Attachment 1

RFI Detailed Response

MG Planning Pty Ltd

Figure 2: Extract of Section 01 A0300

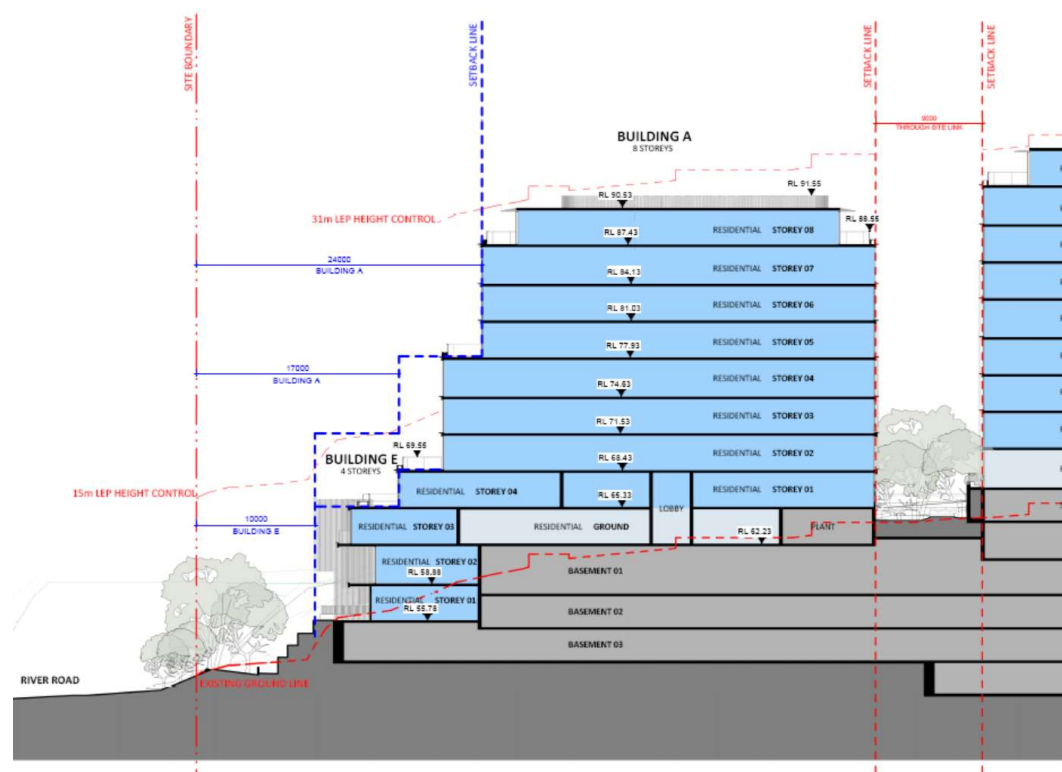
Council has raised concern that Building C is at least 9 storeys and is non-compliant with Figure 10 of Locality 8 – St Leonards South Precinct of Part C Residential Localities LCDCP 2010 which permits a maximum of 8 storeys. Further concern has been raised that Building A is 8 storeys and not stepped between 6 and 8 storeys in accordance with Figure 10 of the DCP

In response to Council's concern the proposed development has been amended to remove 1 full storey from Building C and to step Building A as suggested (refer Figure 2 below).

Figure 4: Extract of Section 01 A0303 Section 04

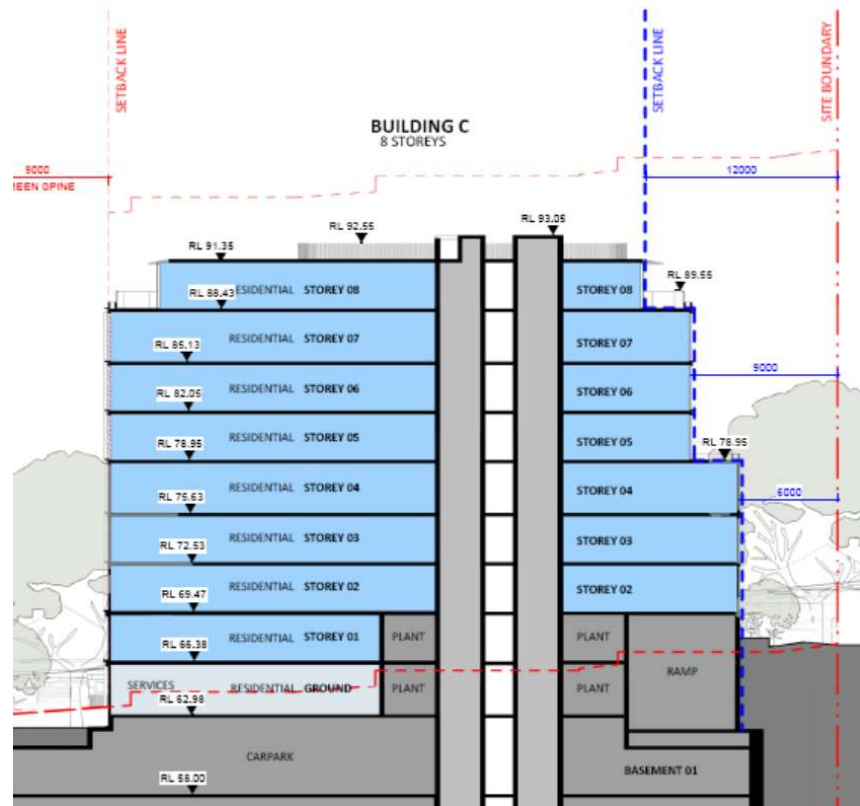
Council has indicated that the proposal seeks a technical departure from the habitable building separation standards within the ADG to the northern boundary without sufficient detail to substantiate a non-habitable interface. Further information is also sought on the relationship with future development in Areas 16 and 17 to the north.

Above 4 storeys the buildings are setback 9m (refer Figure 4 below). The ADG requires an 18m separation for buildings between the 5th and 8th storeys for a habitable to habitable interface. Accordingly, this setback is also fully complies with the ADG requirement and allows for a habitable frontage on the adjacent development sites to the north.

A non-compliance with the ADG is not therefore proposed with both Buildings B and C fully compliant with the ADG required separation distances.
